UNITED STATES ENVIRONMENTAL PROTECTION AGENCY
REGION V

DATE: OCT 07 1986
SUBJECT: Meeting Summary - Johns-Manville, Waukeyan, Illinois
Brad Bradley, Remedial Project Manager TB
FROM: Ill/Ind Unit
Johns-Manville-Waukeyan, Illinois Site File
TO:
Thru: Russell E. Diefenbach, Chief
Illinois/Indiana Unit
Date of Meeting: September 12, 1986 at 9:00 A.M.

Subject: Meeting Summary - Johns-Manville, Waukegan, Illinois Site

U.S. EPA Guidelines For An Acceptable Remedy For
The Johns-Manville-Waukegan Disposal Area

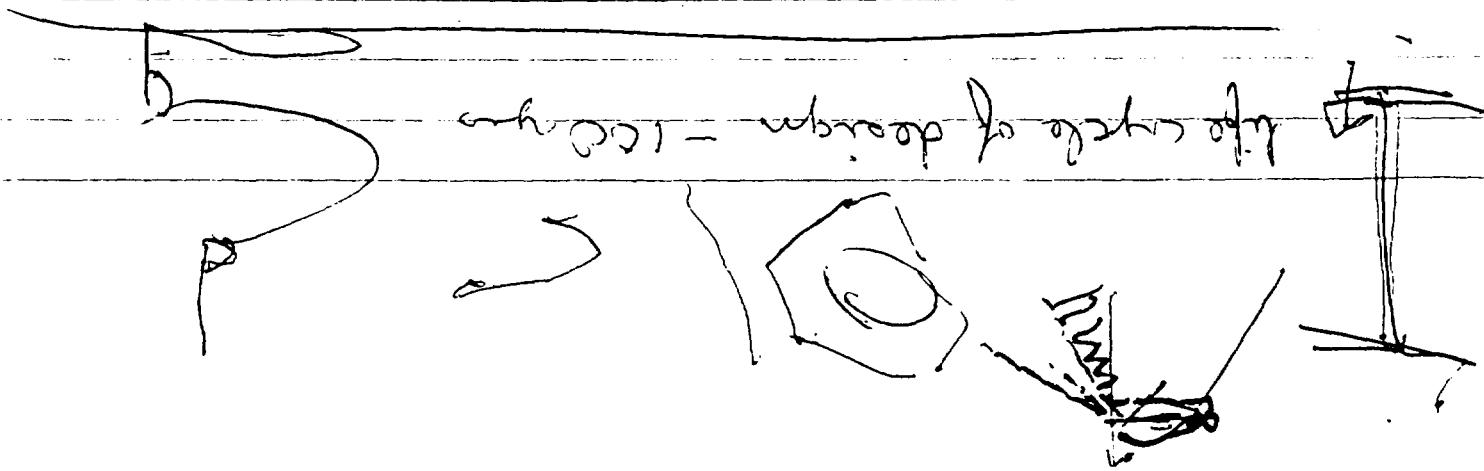
Ditch cutting of actual RA recommendation

→ Don't cut dips on S slope

1' 1' 8" 6" → bottom
↓ ↓ ↓ top

1/2 way up slope

FIGURE 2-3

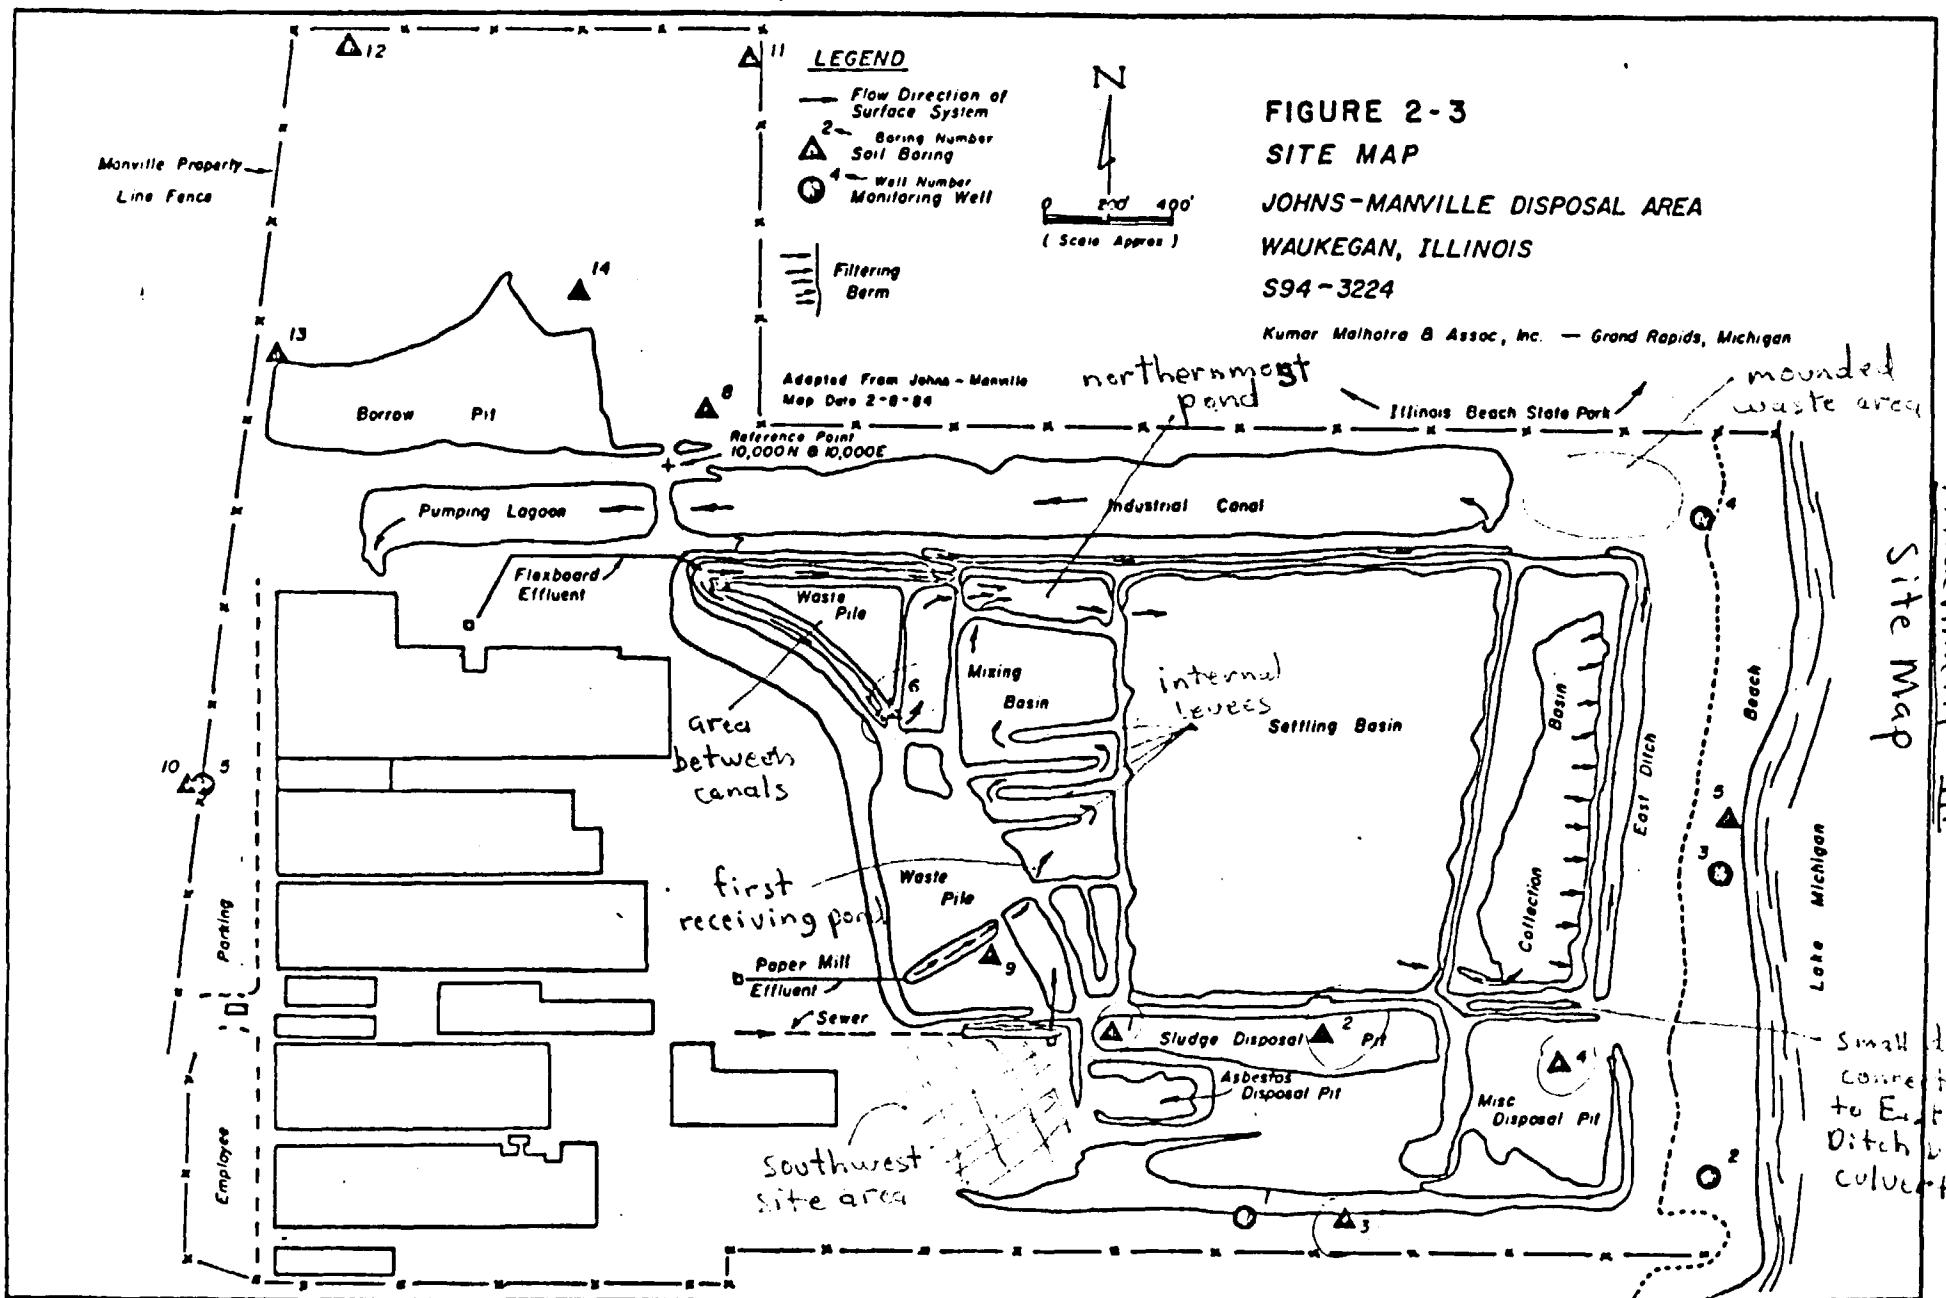
- Johns-Manville (J-M) presented a map dated November 2, 1981, which indicated the depth to sludge in the ponds comprising the front end of the wastewater treatment system, including the settling pond. A site map is included as Attachment III to this report. The depth to sludge gradually increased from about six inches in the first receiving pond to approximately two feet in the

northernmost pond (see Attachment III). In the settling pond, the depth to sludge ranges from six inches to ten feet. It must be noted that these 1981 soundings are inaccurate for assessing the exact present situation, but are useful in gaining a general understanding.

- There is no set schedule or pattern for dredging the sludge at the site. Dredging is performed as needed, using a mudcat for the centers of the ponds and a clamshell or backhoe for the edges. The sludge is loaded into trucks and dumped into the sludge disposal pit. Sludge was formerly dumped in the areas between the canals (see Attachment III).

- As part of the soil cover remedy outlined in the draft FS report, the southwest corner of the site (see Attachment III) would be cleared of all debris and planted, and the beach area would be cleaned up.

- The industrial canal was once a waterway to the lake. The east end was later filled in, creating a mounded area near the beach (see Attachment III). This mounded area will be cleaned up, and dikes will be constructed along the depressions on the north side of the industrial canal to prevent ^{surface} water from migrating across the site boundary. Surface water would tend to flow into the industrial canal due to its surface elevation; however, during high water conditions, the potential exists for the canal water to intermix with off-site surface water. Twenty percent of the water used in J-M's manufacturing processes is pumped from Lake Michigan; the balance comes from the wastewater treatment system.

- The small ditch by the east ditch (see Attachment III) will be filled in.

- Riprap will be placed along the entire settling pond and any long berms in the wastewater treatment system. J-M was not sure of what would be done with the series of internal levees at the front end of the system (see Attachment III). Due to dredging machinery traffic, the levees might be covered with soil, or only the corners may be covered with riprap. The levees were built in the 1970's from pipe and shingles, some of which contained asbestos cement.
